**LOCAL HISTORIC DISTRICT:** Fourth Ward

**PROPERTY ADDRESS:** 522-524 N. Pine Street

**SUMMARY OF REQUEST:** Driveway

522 N PINE ST. — FOURTH WARD  
CASE NO. HDC-2019-00184

PROPOSED

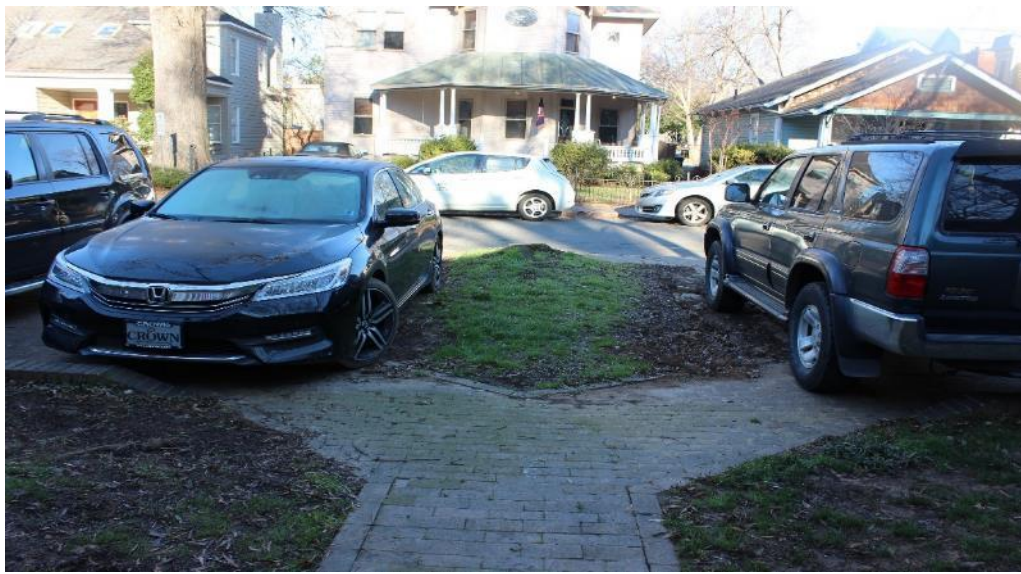
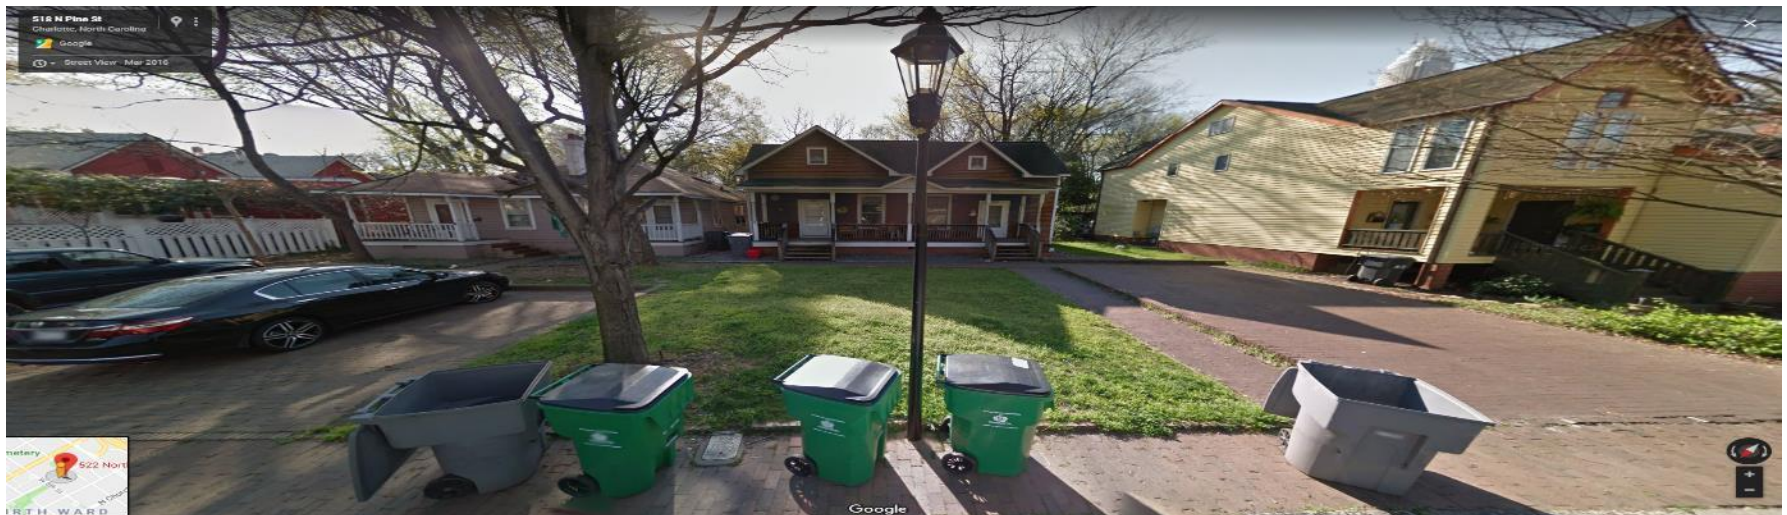
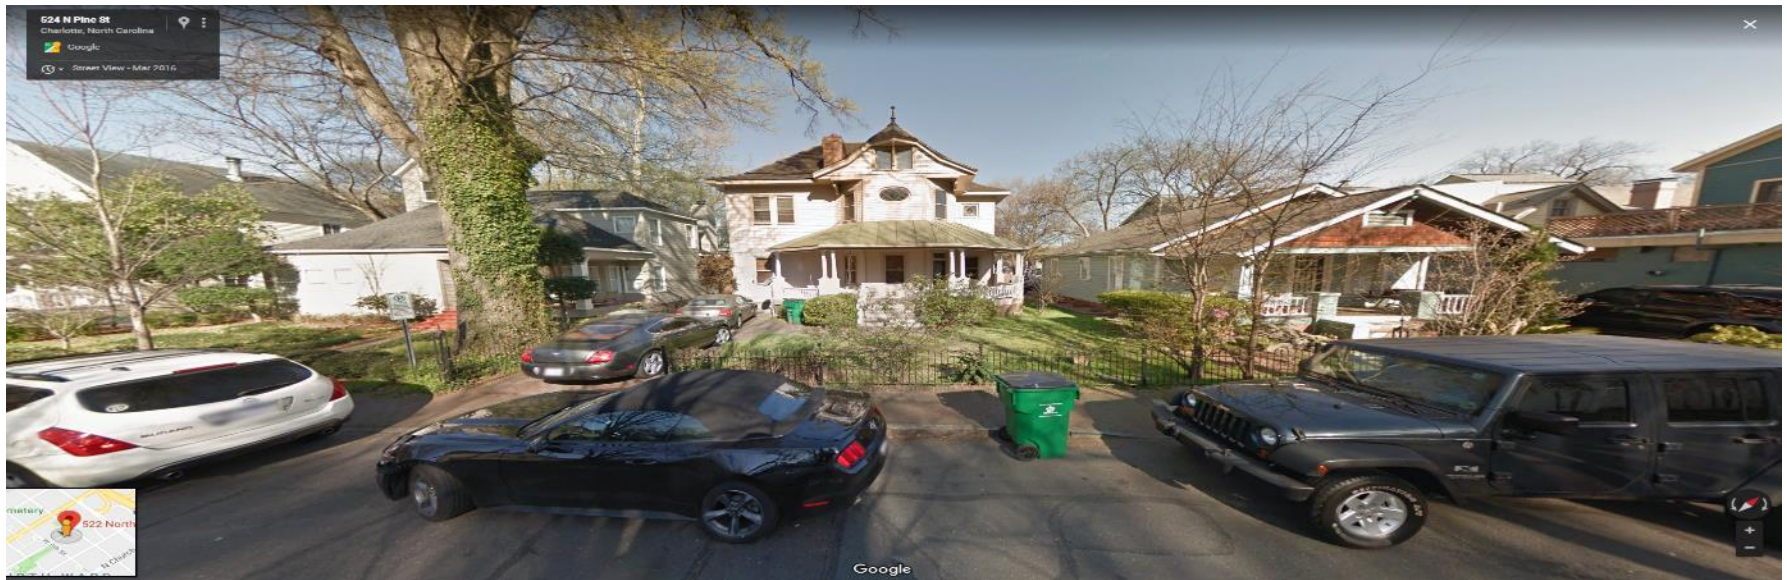
The proposal is design changes to existing parking areas. The brick parking areas were originally approved by the HDC in 1980. The existing parking areas measure approximately 15' wide x 20' deep. The landscape area between the parking areas measures approximately 12' wide. Proposed material is concrete. The existing brick edging that measures approximately 7" high x 8" wide, will be retained and repaired. The tree that has been removed was a city tree.

1. The Commission will determine if the proposed driveway changes meet the Design Guidelines.
2. Minor revisions may be reviewed by staff.
